ADDENDUM #4

**PROJECT: RENOVATIONS TO THE SCOTLANDVILLE BRANCH LIBRARY - PHASE II
CITY PARISH PROJECT NO. 21-ASC-CP-1449**

ADDENDUM Attachment to City Parish Addendum 4
January 27, 2025

RE: **Renovations to Scotlandville Branch Library – Phase 2**
EBR Project # 21-ASC-CP-1449

02 WALL SECTION
3/4" = 1'-0"

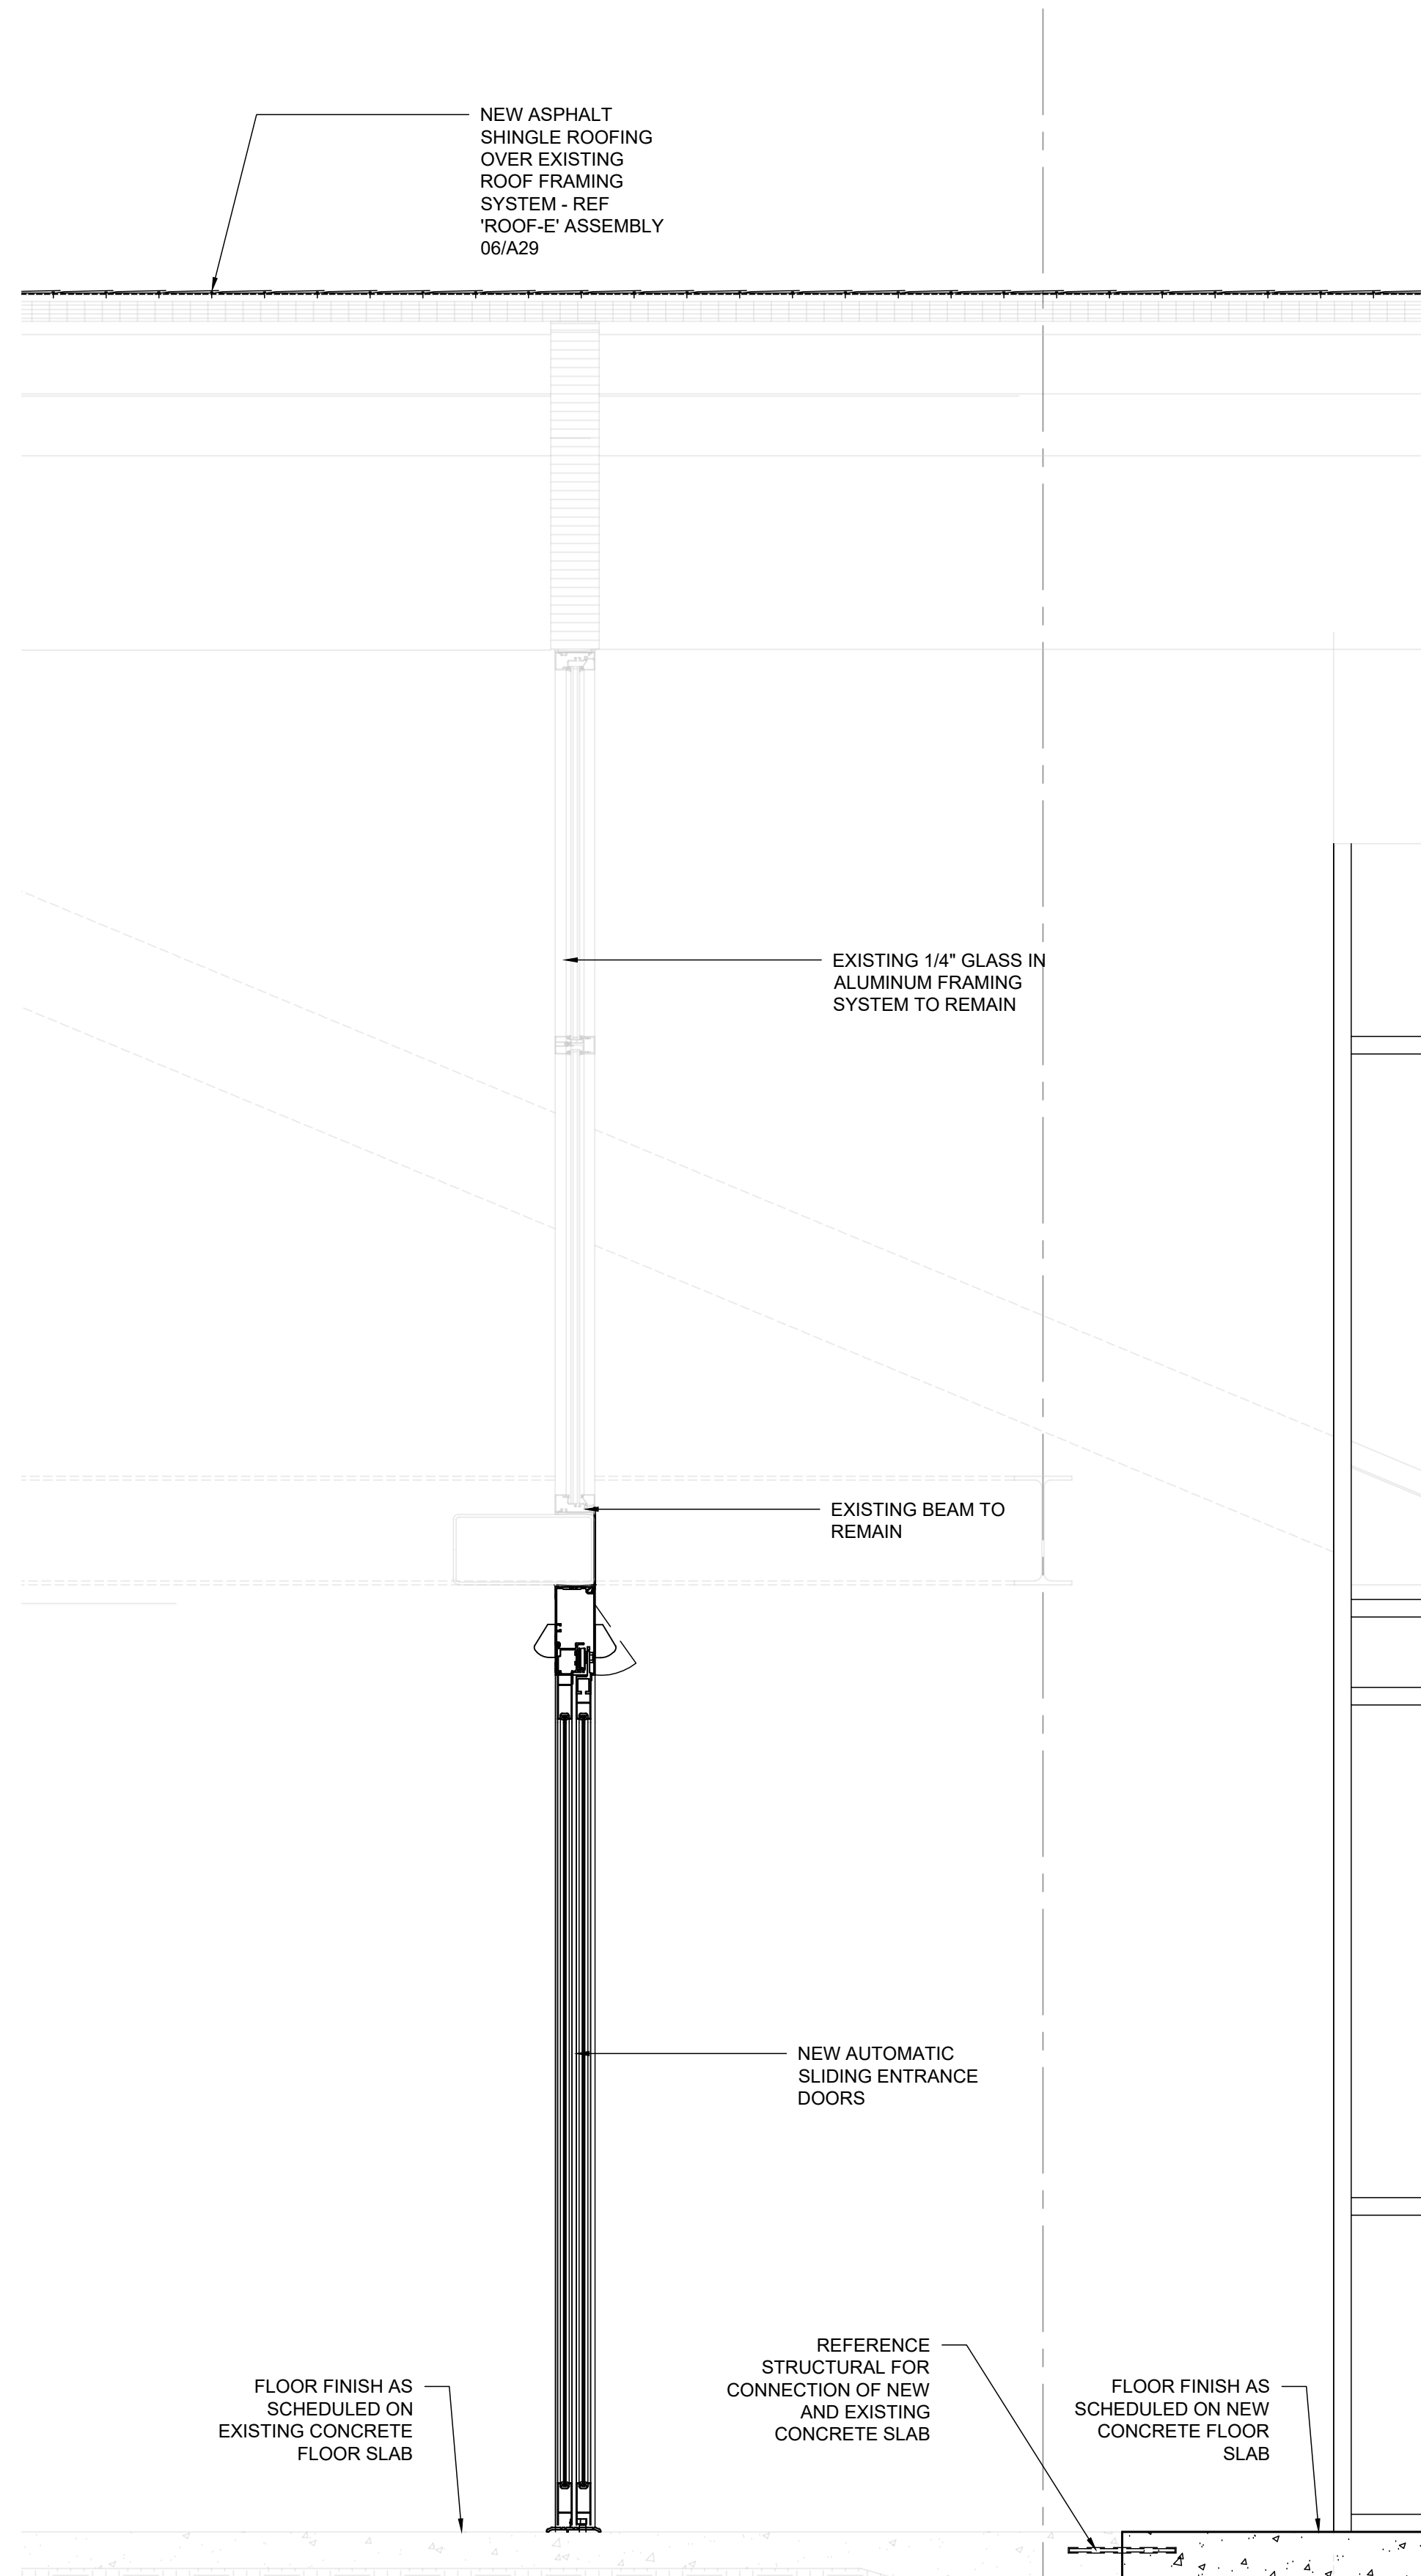
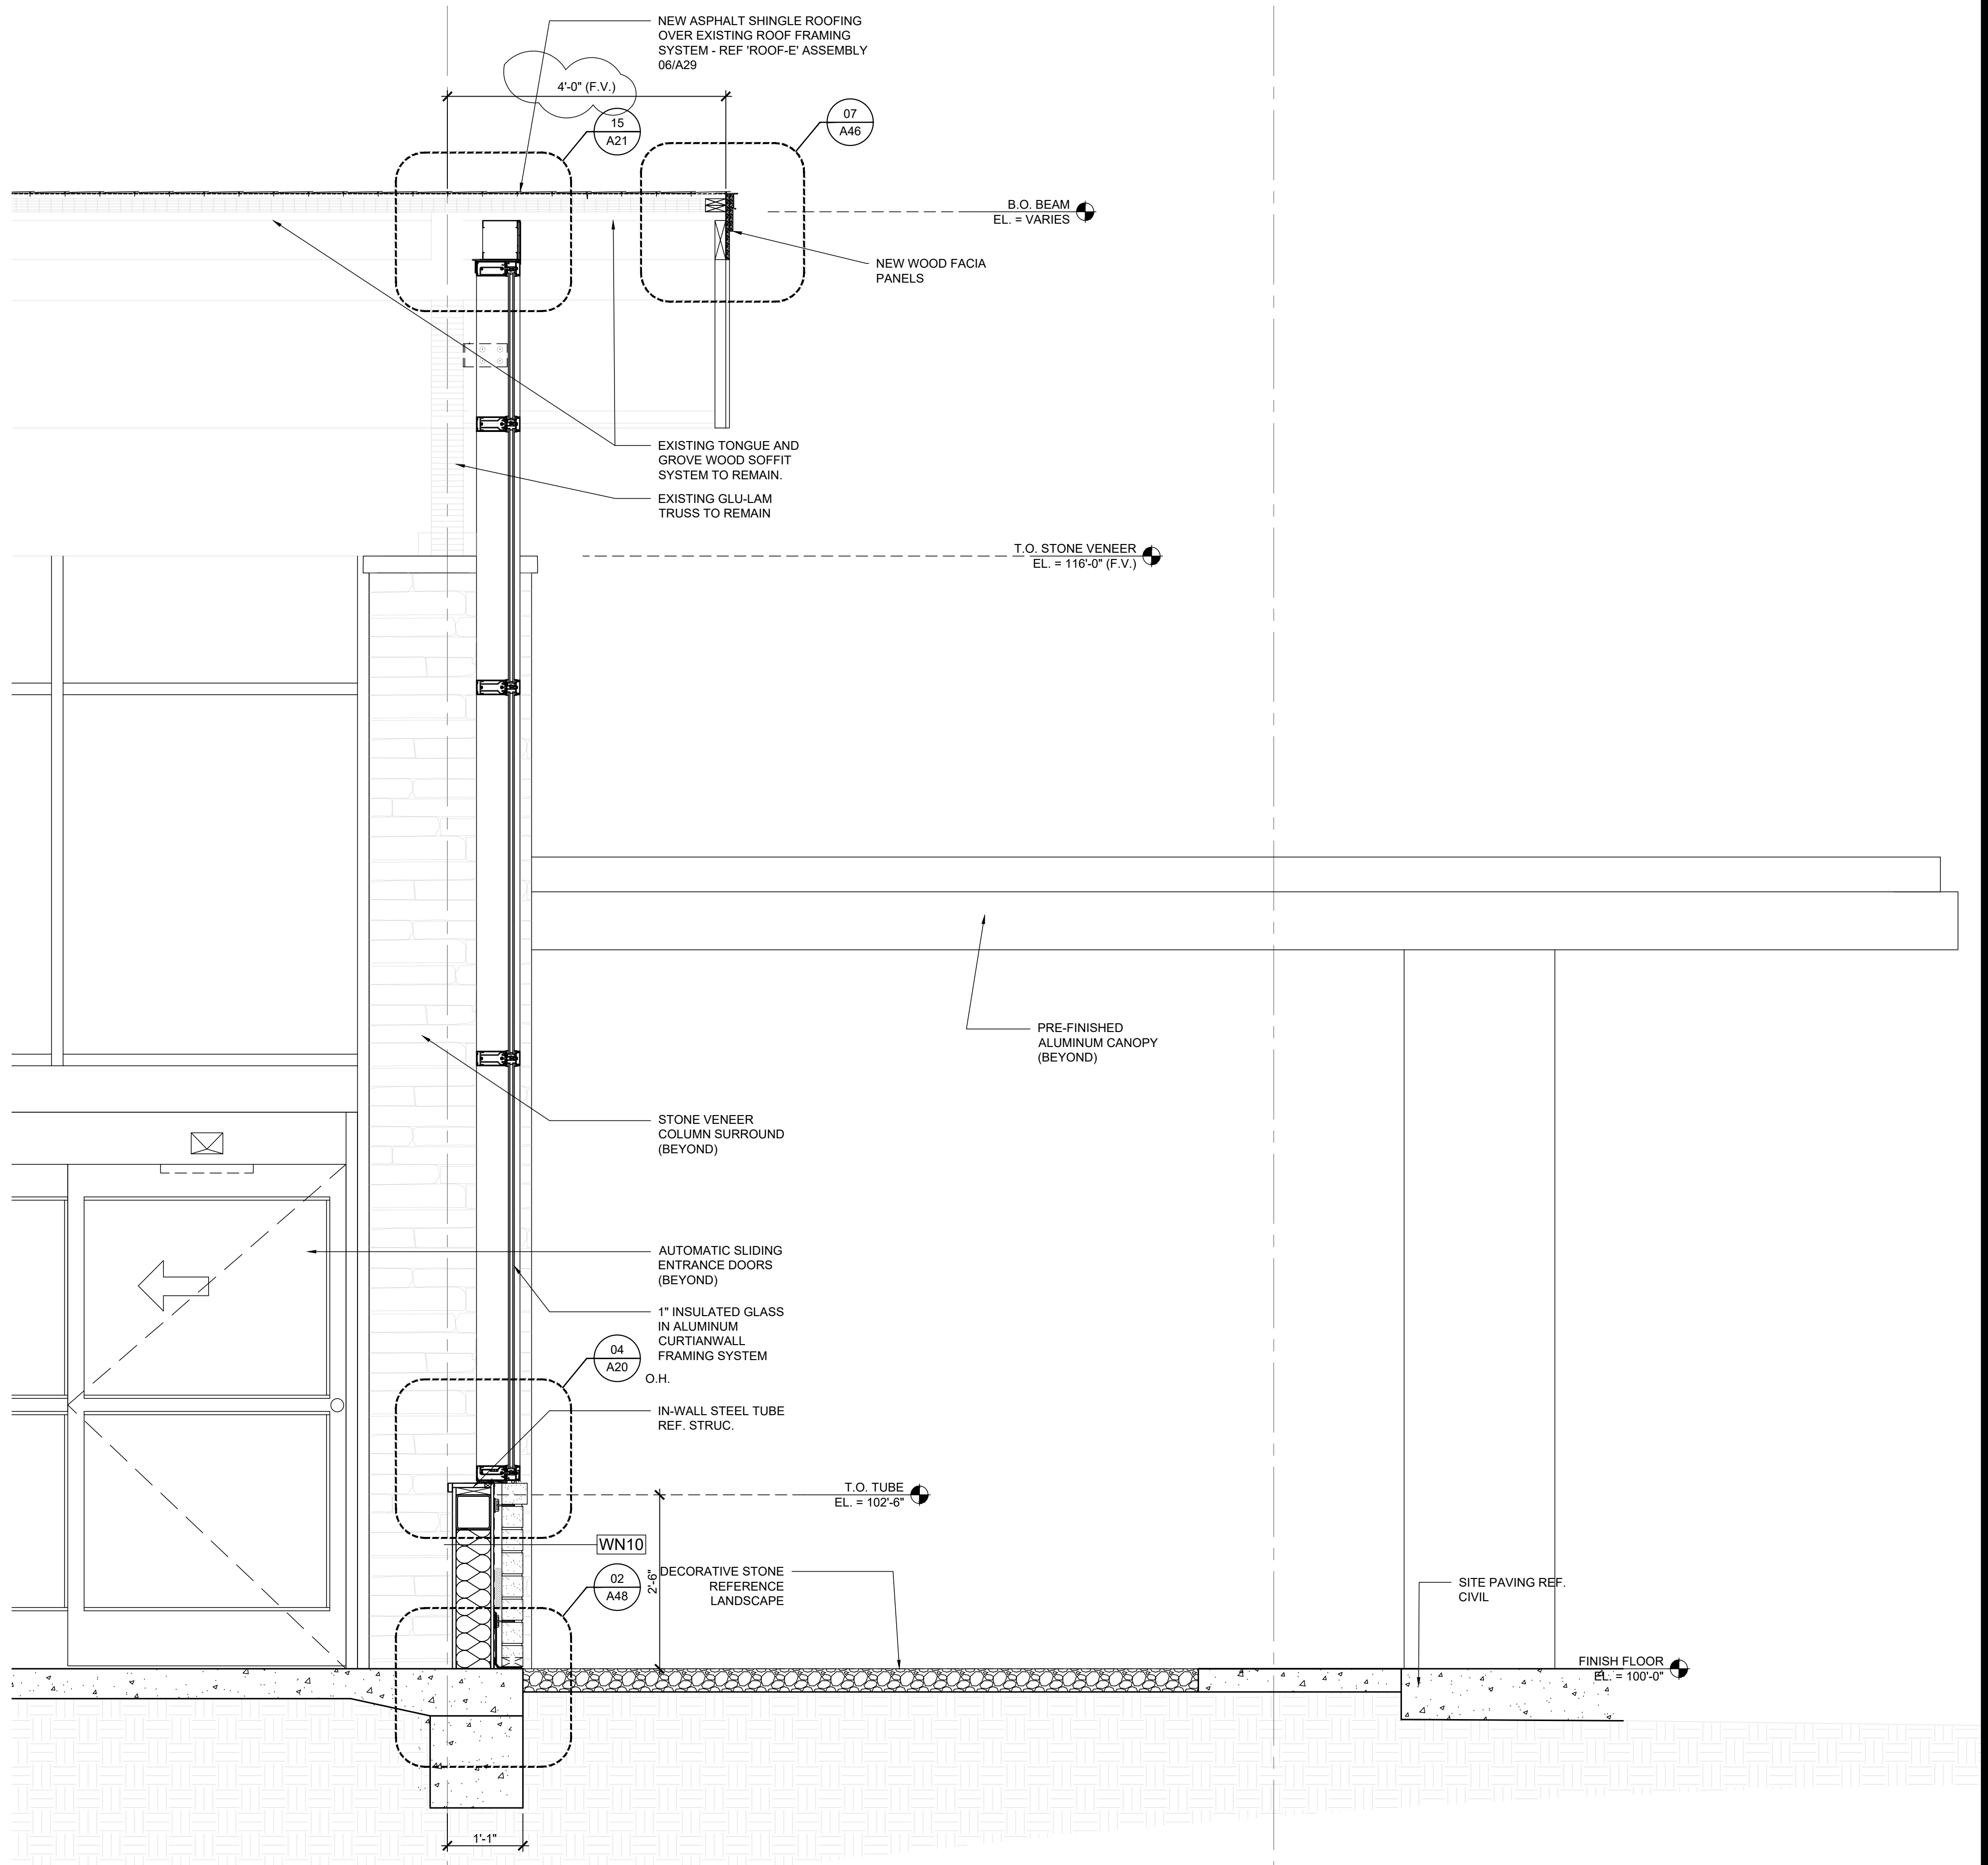
A41 - Revise overhang width to 4'-0" F.V.

1 ENLARGED SITE PLAN - MECHANICAL YARD
SCALE: 1/4" = 1'-0"

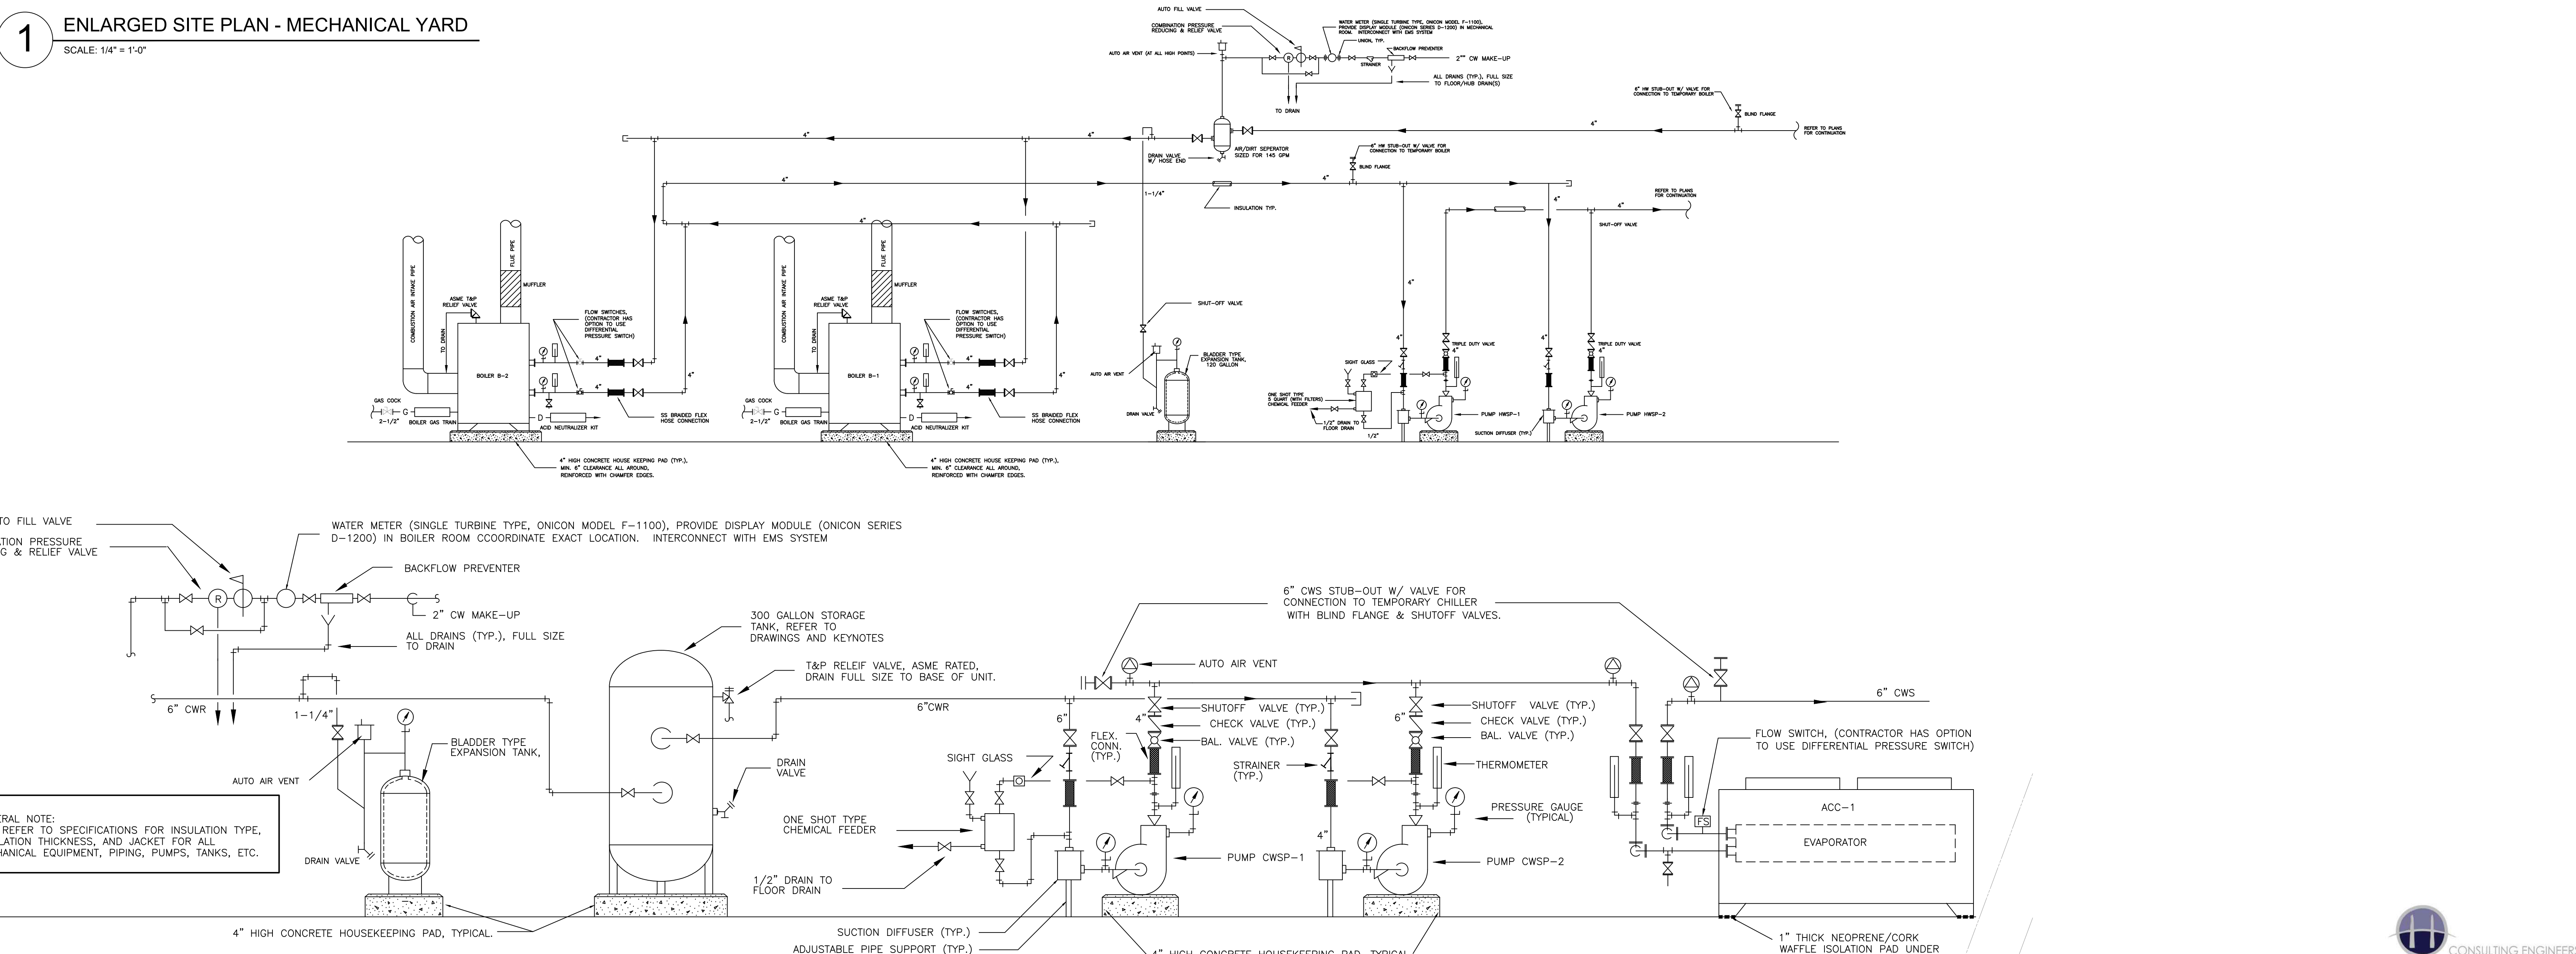
2. M2.01 Detail #1 Note 30 is listed twice one the underground which is for the domestic water to the building. There is also a branch off of this main that goes under ground to a separate location. Where does this second location serve? Was this part of phase one and do we need to disregard. This is not located on the plumbing drawings but is located on the Mechanical.

- a. *Contractor to refer to resubmitted sheet M2.01 within this addendum.*
3. M2.01 Detail #1 shows new chill water pipes to run on tee post from the pump room to the chiller yard above ground on tee post. Three tee posts are shown to me mounted on an existing sidewalk and the remaining ten are shown in the grass. Are the supports on the sidewalk going to block egress and how are we to mount the tee post to the grass as there is no structural detail?

11. On sheet M2.01 on Detail #2 there is no apparent air separator in the chill water system. One is shown on the Heating hot water. Is one need on the chill water and if so what size?
 - a. *No*

- a. *Contractor to figure in bid additional footings (minimum 24"x24"x12", with reinforcing 3 #5's in each direction) for all pipe supports shown within grass area.*

- a. Delete and replace with new M2.01 included within this addendum. The following items were revised:
 - 1) Plan keynotes are now reflective on the enlarged plan.
 - 2) Clarification on whether equipment is remaining or being removed, etc.

- a. Note #11 delete reference to NEMA 3R ofr the CWSP-1.2 VFD's; provide NEMA 12 enclosures for CWSP-1,2 VFD's.
